Access Compliance Report

Public Rights-of-Way

Intersection ID: 14830	Main Street: ALBERTO_ST	Cross Street: CRESCENT_AV	Location: NW
ADA ID: D07D1852A302	Ramp Type: Perp	Initial Pass/Fail: Fail	Overall Compliance: No
		Severity Score: 12.5

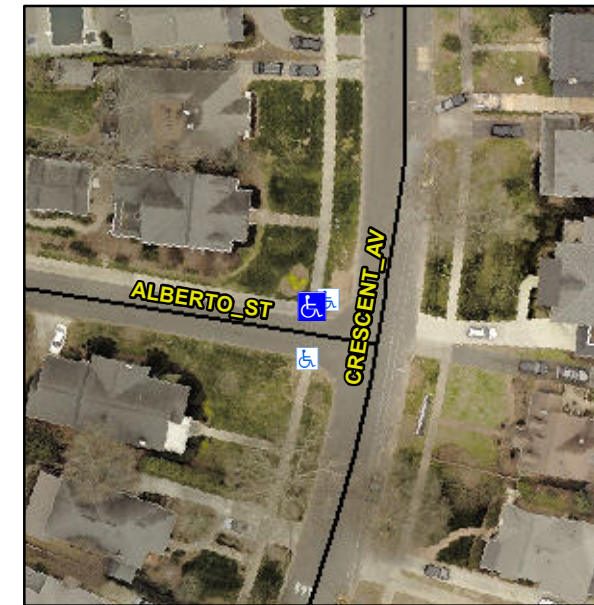
R304.2.2

Compliance	Description	Data	Compliance	Description	Data
N/A	Ramp Length (in)	58.0	No	Ramp Slope (%)	8.8
Yes	Ramp Width (in)	72.0	Yes	Ramp XSlope (%)	0.8
N/A	Flare Type LT	N/A	N/A	Flare Type RT	N/A
N/A	Flare Slope LT (%)	N/A	N/A	Flare Slope RT (%)	N/A
N/A	Flare Traversable LT?	N/A	N/A	Flare Traversable RT?	N/A
N/A	Landing Length (in)	N/A	N/A	DWS Provided?	N/A
N/A	Landing Width (in)	N/A	N/A	DWS Contrast?	N/A
N/A	Landing Slope (%)	N/A	N/A	DWS Length (in)	N/A
N/A	Landing X Slope (%)	N/A	N/A	DWS Full Width?	N/A
N/A	Landing Curb? (Y/N)	N/A	N/A	DWS Offset (in)	N/A
N/A	Shared Landing?	N/A			
N/A	Gutter Ponding?	N/A	N/A	Gutter Slope (%)	N/A
N/A	Gutter Lip Ht (in)	N/A	N/A	Gutter X Slope (%)	N/A
N/A	Painted X Walk1?	No	N/A	Painted X Walk2?	N/A
	X Walk 1 Direction	To SW		X Walk 2 Direction	N/A
N/A	X Walk 1 Width (in)	N/A	N/A	X Walk 2 Width (in)	N/A
	X Walk 1 Slope (%)	2.0		X Walk 2 Slope (%)	N/A
	X Walk 1 X Slope (%)	0.5		X Walk 2 X Slope (%)	N/A

Remove & Replace Entire Ramp.
